DA2019.359 Merimbula Airport Upgrade - Runway Extension

SUBMISSIONS REPORT

Merimbula Airport Upgrade – Runway Extension

Figure 2-2 Updated impact areas now proposed.

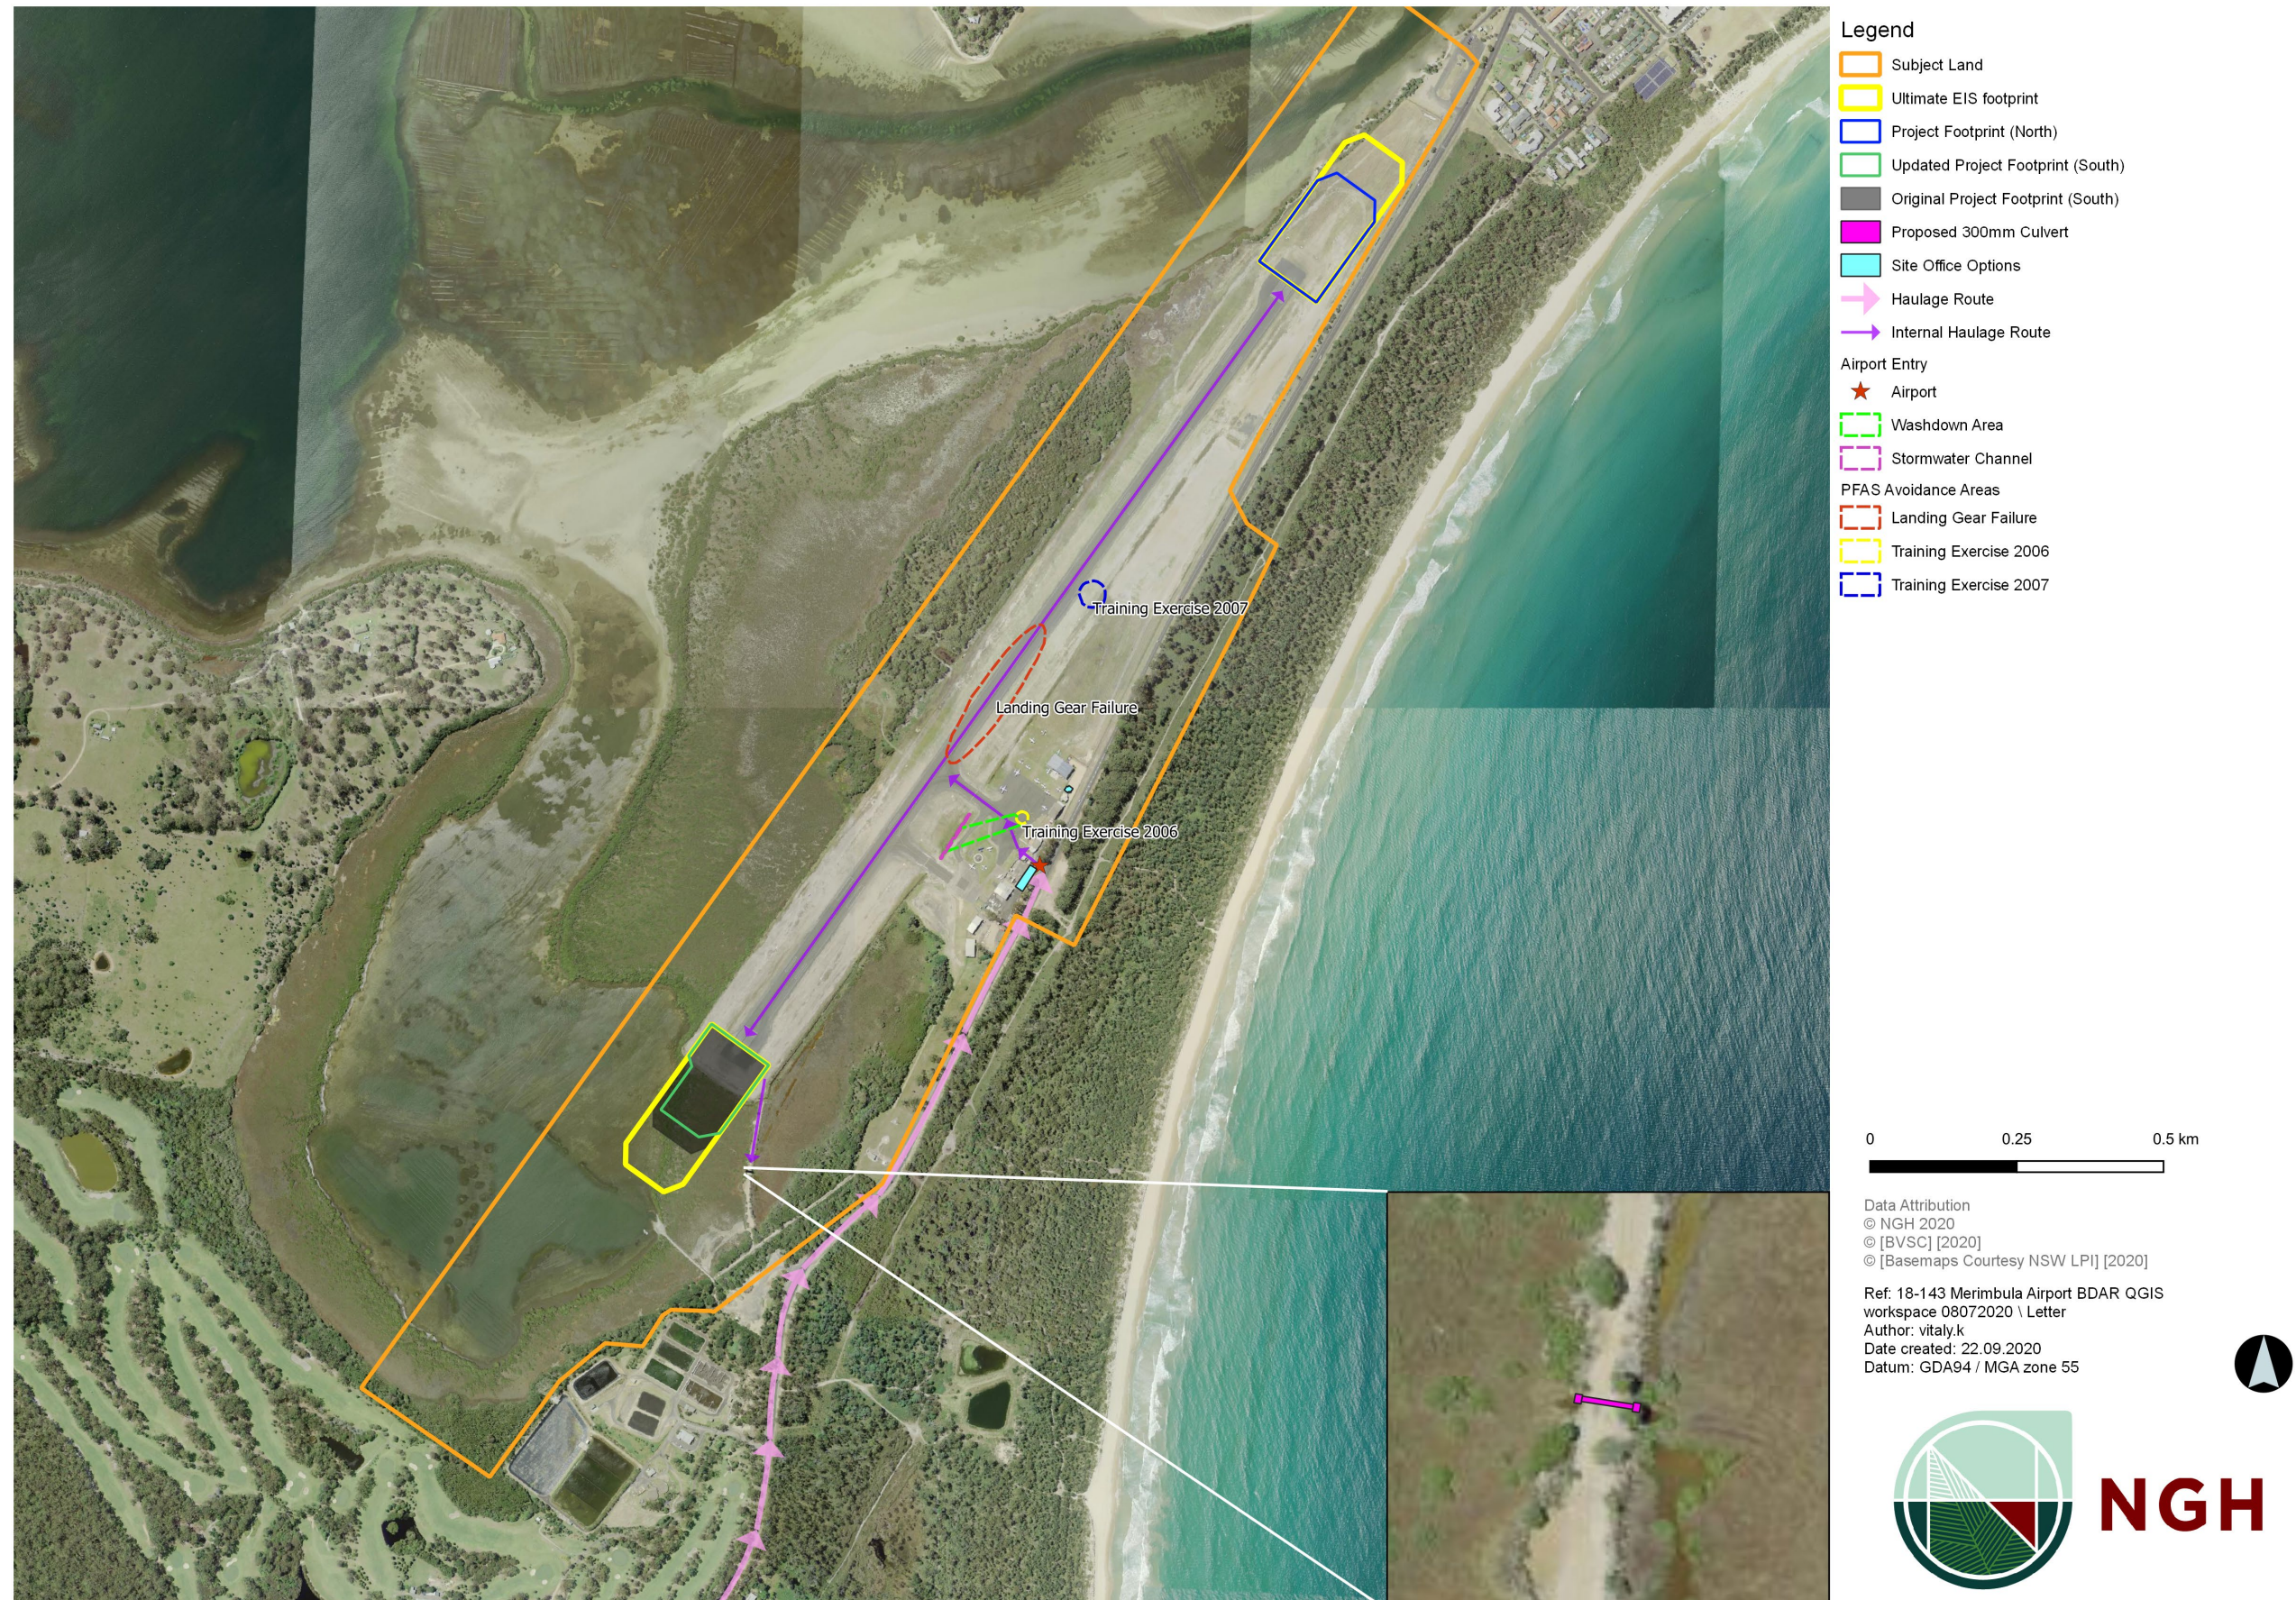
<p>Construction access</p> <p>The EIS states that “the proposal would utilise existing access off Arthur Kaine Drive for truck and equipment access during construction.” Is this the same access that airport patrons use to access the site? If so, the Applicant must provide an assessment of the safety and traffic implications associated with this.</p>	<p>The access point that would be used is now shown on Figure 2-2 and as described in sections 2.2.1 of this SR.</p> <p>BVSC has considered the safety and operation of the haulage route and consulted with TfNSW, who raised no objection.</p> <p>The main entry has been used for other airport operations permitting heavy vehicles to the site and aligns directly with access to airside operations allowing straight access with no turning required in the areas of the public carpark that the vehicles would travel through (as shown below).</p>

Issue	Response
	 <p>(Adapted from Figure 2-2) – direct access for construction vehicles to airside aprons from Arthur Kaine Drive.</p> <p>Access to the works areas within the site would be via the main entry, through the existing vehicle access gate, via the aprons and along runway, using existing formed paths.</p> <p>A detailed traffic management plan would be prepared prior to construction and would be included in the CEMP for the development as per the updated traffic mitigation measures listed in section 8 of this report. The traffic management plan would be implemented during construction to manage the access point and direct traffic safely and efficiently through and past the site.</p>
<p>Development Control</p> <p>The assessment needs to provide consider the relevant requirements of the Bega Valley Development Control Plan 2013.</p>	<p>The assessment against the DCP is provide in Section 5 of this SR. The provisions of Sections 5 and 6 of the DCP relevant to the proposed Runway Extension (construction and operation) are discussed in Table 5-1.</p> <p>The development is considered to be consistent with the requirements of the DCP specifically relating to:</p> <ul style="list-style-type: none"> • Aboriginal Heritage • Social and economic impacts • Sustainable design principles • Potential hazards • Off-street car parking • Traffic management, and • Soil and stormwater management.
